Groundwater Transfer Review Summary Form

Transfer/PA # T- 14748

Application: T-14748

Applicant Name: City of Salem

Well Location Map

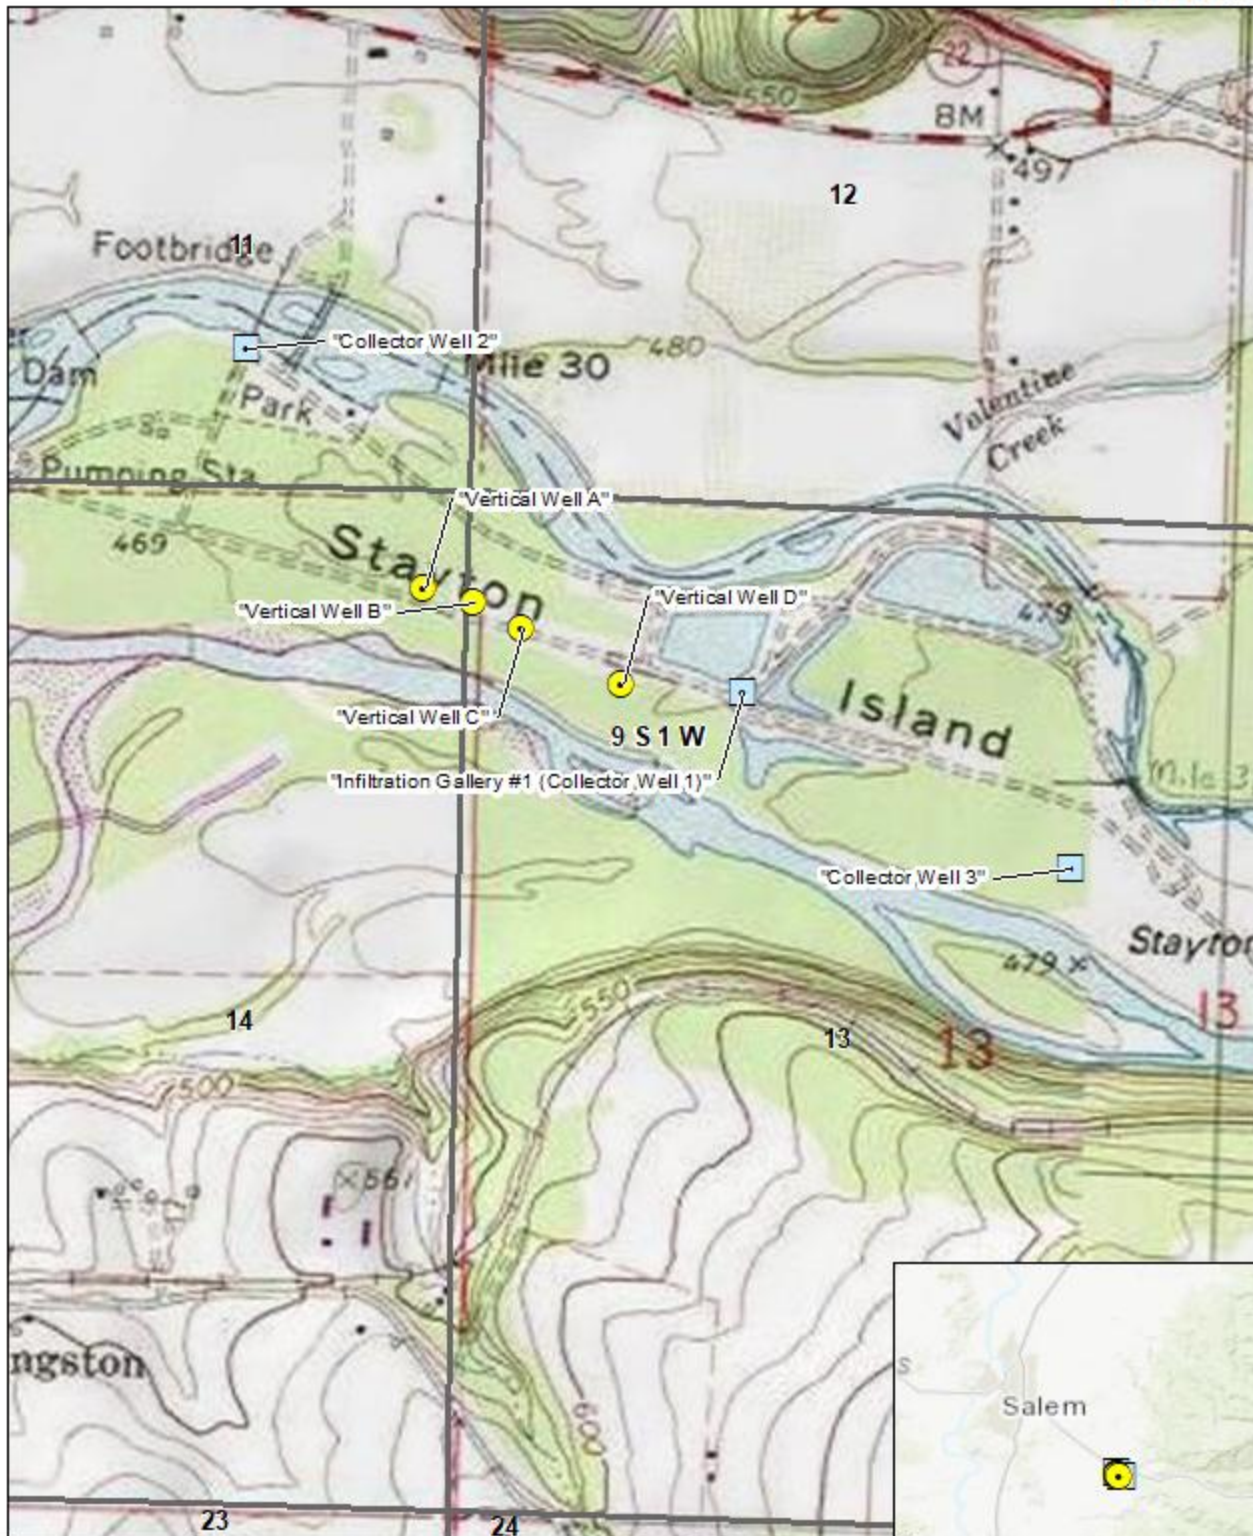
-
1. Basic description of the changes proposed in this transfer: Applicant proposes to add 4 APOA (proposed "Vertical Well A", "Vertical Well B", "Vertical Well C", and "Vertical Well D") to Claim GR-3510, which currently authorizes 12.3766 cfs of year-round Municipal Use from 3 POA: "Infiltration Gallery #1" (a.k.a. "Collector Well 1" / LINN 2676), "Collector Well 2" (Not Built), and "Collector Well #3" (MARI 71038).

2. Will the proposed POA develop the same aquifer (source) as the existing authorized POA?
☒ Yes ☐ No Comments: All of the authorized and proposed wells produce/would produce groundwater from the alluvial aquifer system.

5. a) Will this proposed change, at its maximum allowed rate of use, likely result in an increase in interference with **another ground water right**?
☐ Yes ☒ No Comments: The authorized and proposed POA locations are on an island between two channels of the North Santiam River and produce from shallow alluvium which is very hydraulically connected to surface water. Any impacts to groundwater would likely be minimal and limited to within the boundaries of the island. Although other groundwater rights (claims) do exist on the island, they are all owned by the City of Salem. Therefore, the proposed change is unlikely to increase interference with another groundwater right.

6. a) Will this proposed change, at its maximum allowed rate of use, likely result in an increase in interference with **another surface water source**?
☐ Yes ☒ No Comments: The authorized and proposed POA are very hydraulically connected to the North Santiam River. No increase in interference with surface water is anticipated due to the proposed change.

8. What conditions or other changes in the application are necessary to address any potential issues identified above: None
9. Any additional comments: None
